S30-061, S30-062, S30-081, S30-104
Ball Valve/Handle Prepack (Right Handle)

215-1897 Rev. A; ECO 19-05-002F
© 2019 Bradley

Ball valves prior to June 28, 2019	Ball valves after June 28, 2019

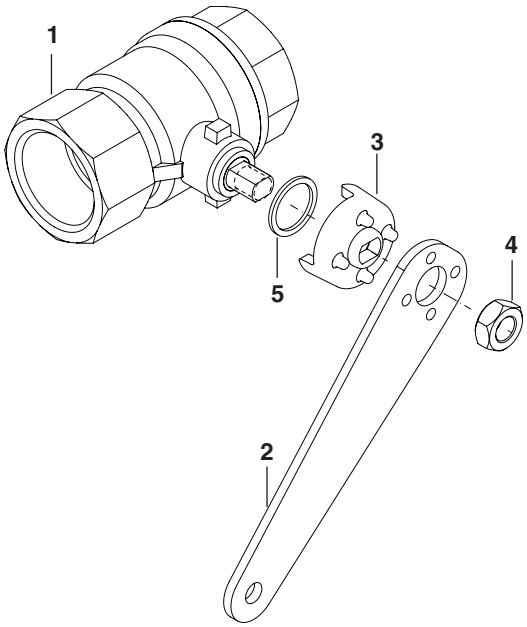
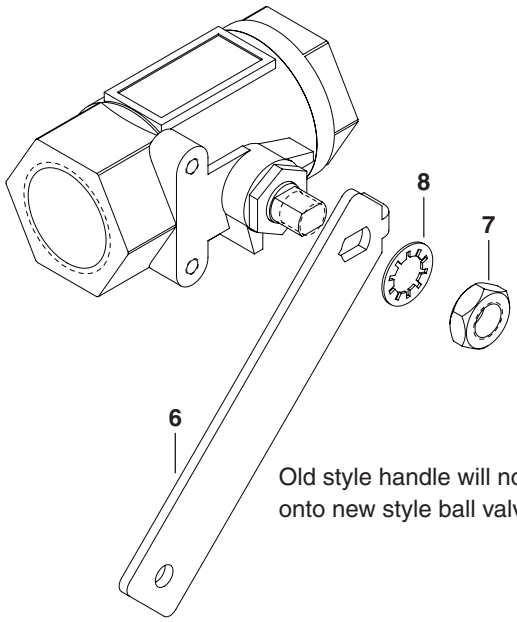
Handles on ball valves prior to June 28, 2019 are not compatible with the new version of ball valves. One of the below listed kits is required to replace the handle.

Old style handle will not fit onto new style ball valves.
